COMMITTEE OF THE WHOLE JUNE 14, 2011

ZONING BY-LAW AMENDMENT FILE Z.06.058 DRAFT PLAN OF SUBDIVISION FILE 19T-06V10 MOSAİK PINEWEST INC. WARD 3

**Proposed Draft Plan of Subdivision
 as Red-Lined on June 14, 2011**

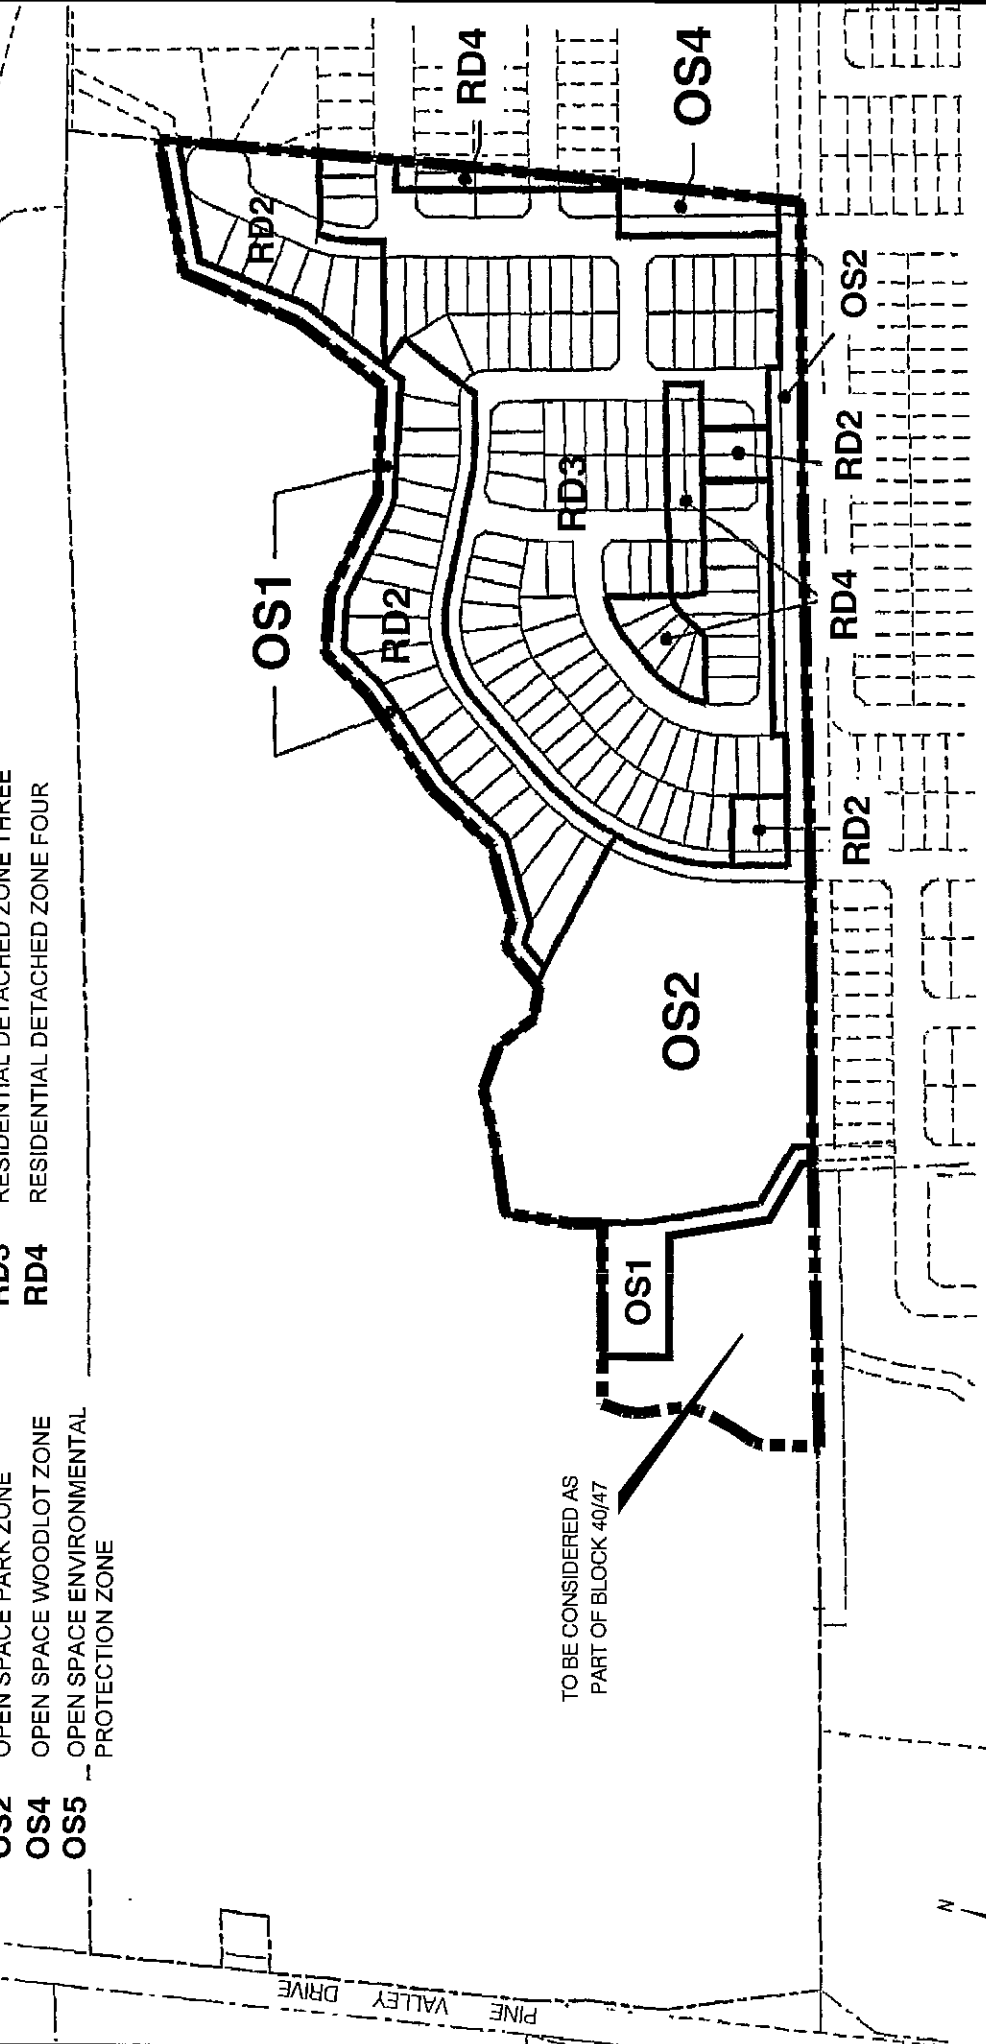
The Draft Plan of Subdivision as shown on Attachment #4 has been red-lined with concurrence from the applicant to delete Lot 144, which includes an existing residential dwelling, within the open space valley. The final disposition of Lot 144 will be dealt with through the final approval of the Block 40/47 Block Plan. A letter from the Block Trustee for Block 40 South and Block 40/47 has been provided to this effect.

1. The Plan shall relate to the draft plan of subdivision, prepared by Humphries Planning Group Inc., drawing #A1, dated November 8, 2010, and revised on March 26, 2011, as red-lined on June 14, 2011 to incorporate the following revisions:

- a) remove Lot 144 (Existing Residential) from Draft Plan of Subdivision File 19T-06V10 (Mosaik Pinewest Inc.).
2. The lands within this Plan shall be appropriately zoned by a Zoning By-law which has come into effect in accordance with the provisions of The Planning Act. Particular zoning categories to be applied are as follows:

**PROPOSED
9m ACCESS
BLOCK**

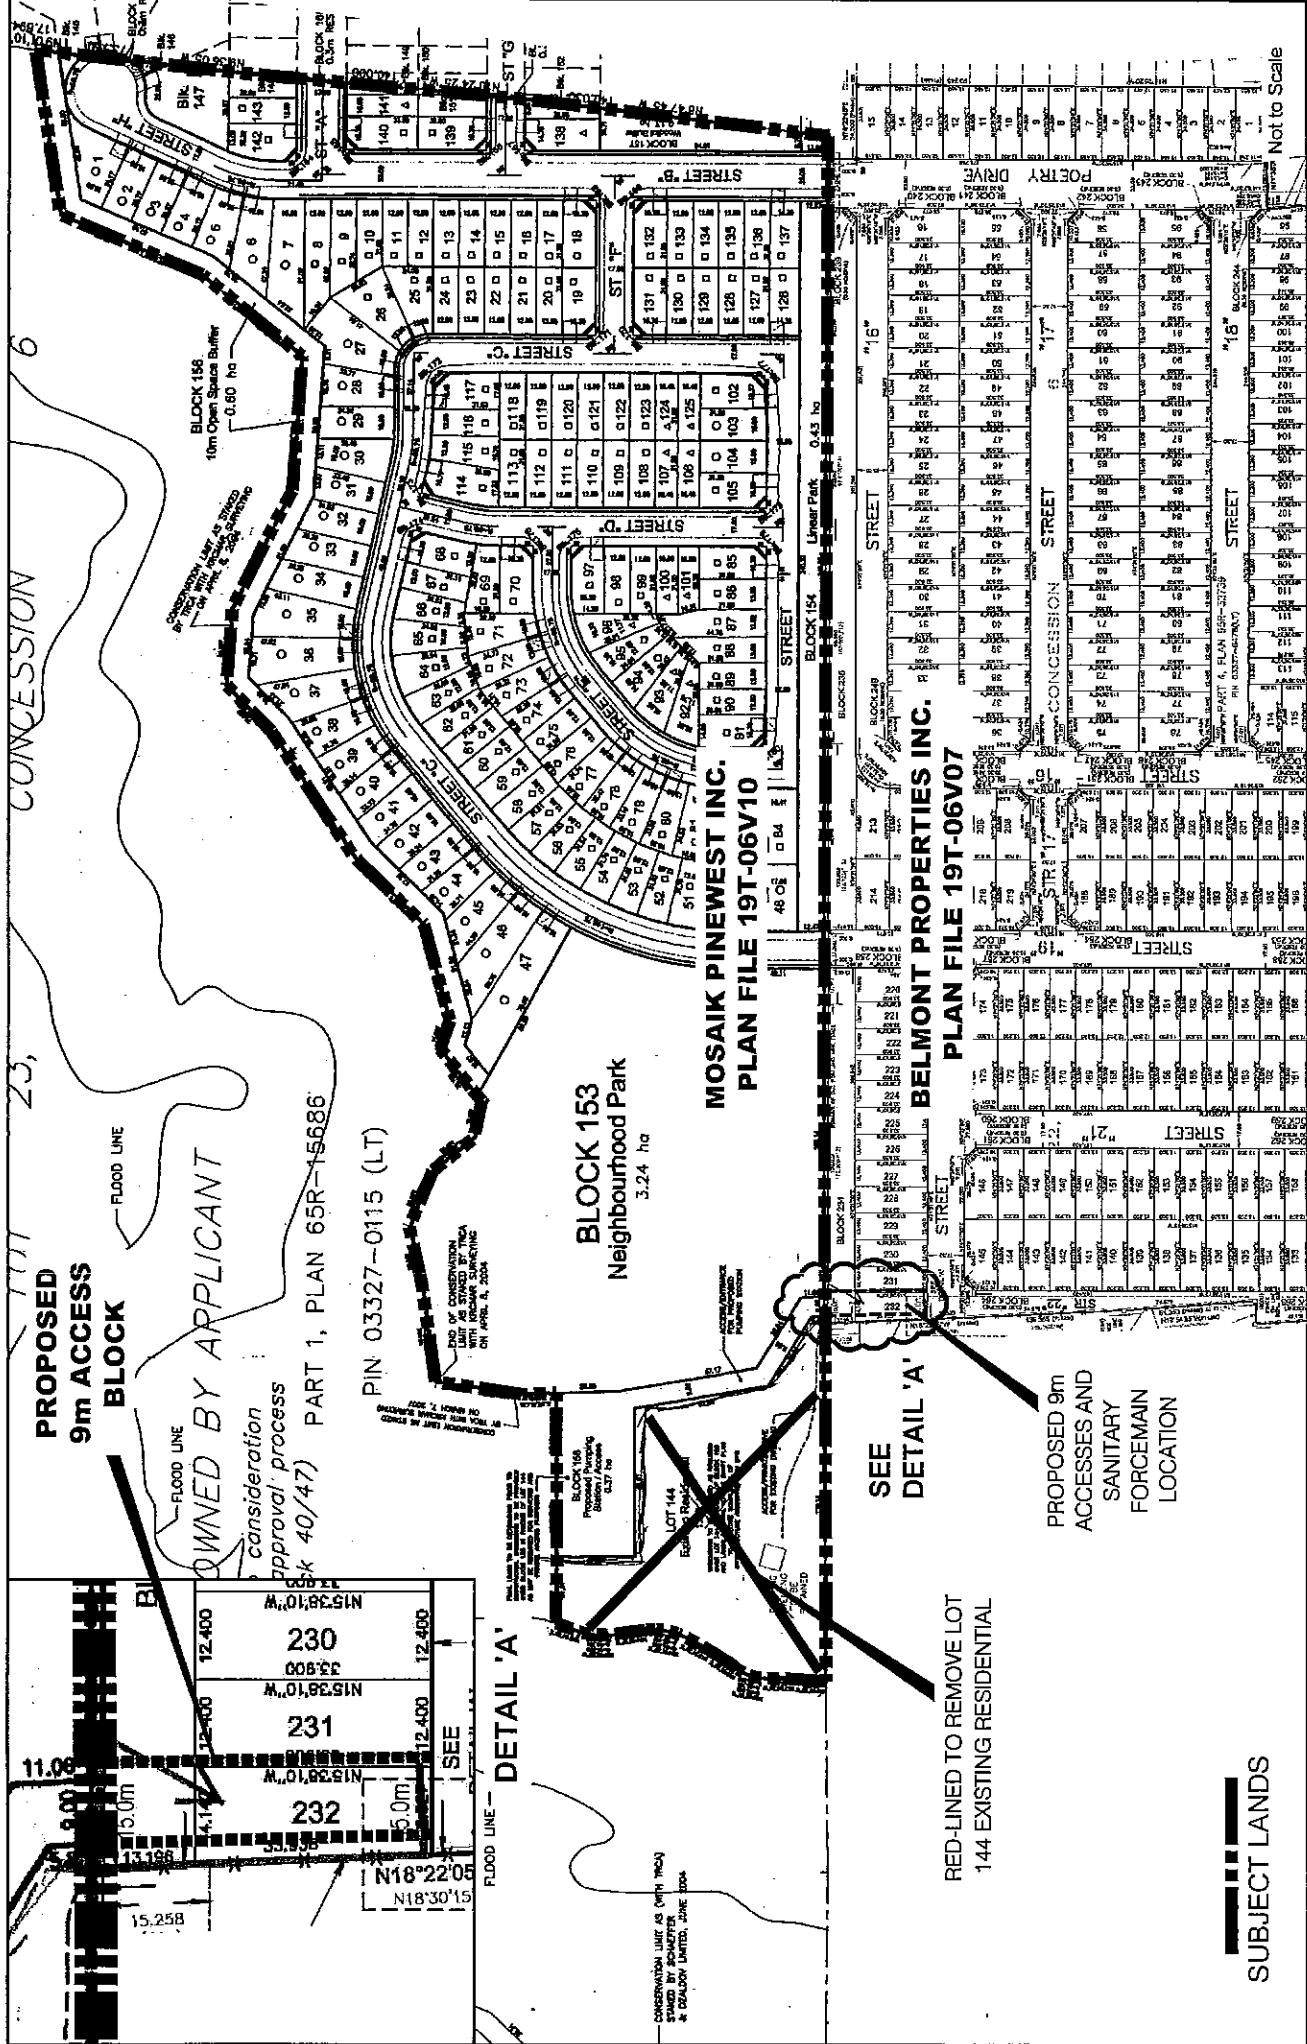
Block 158 on the draft plan was created to locate a pumping station, which the applicant is proposing to access from the approved Plan of Subdivision File 19T-06V07 (Belmont Properties Inc.) to the south. The Vaughan Development/Transportation Engineering Department requires a minimum 9.0m wide access, which the applicant has proposed through the Belmont subdivision, as shown on Attachment #7. These lands must be conveyed to the City, free of all costs and encumbrances. The Development/Transportation Engineering Department has advised that since Phases 1 and 2 of Plan 19T-06V07 have been registered, Belmont Properties Inc. and the Trustee of Block 40 South have agreed to provide the necessary land conveyance to the City through Plan 19T-06V07, Phase 3. The conditions of approval to this effect are included in Attachment #1.

The 9 m wide access block is proposed on lands within the Belmont Properties Inc. (Belmont) Plan of Subdivision 19T-06V07 that is approved and zoned RD3(H) Residential Zone Three, with the Holding Symbol "H" subject to Exception 9(1291) by Zoning By-law 1-88. This access block directly impacts the Belmont Plan as follows:

In order to facilitate the construction and maintain the proposed sanitary pump station on Block 158 on the Plan, the Owner shall convey free of cost and encumbrances to the City of Vaughan a minimum 9.0 metre wide block for the purposes of maintenance road access and sanitary gravity and forcemain sewers external to the Plan, on the adjacent Plan of Subdivision 19T-06V07 (Belmont Properties (Weston) Inc.), Phase 3 lands.

- a) convey to the City a minimum 9.0 metre wide block, ultimate width to be established at detail design stage, for maintenance road, sanitary gravity and forcemain sewers and watermain purposes external to the Plan on the adjacent Belmont Properties (Weston) Inc. 19T-06V07 Phase 3 lands; and,

- b) That Lots 220 to 232 on the Belmont Properties (Weston Inc.) Plan of Subdivision File 19T-06V07 located south and external to the plan be reconfigured to comply with the minimum requirements of Zoning By-law 1-88 and to ensure that no remnant block(s) or part lot(s) remain on the said Plan.
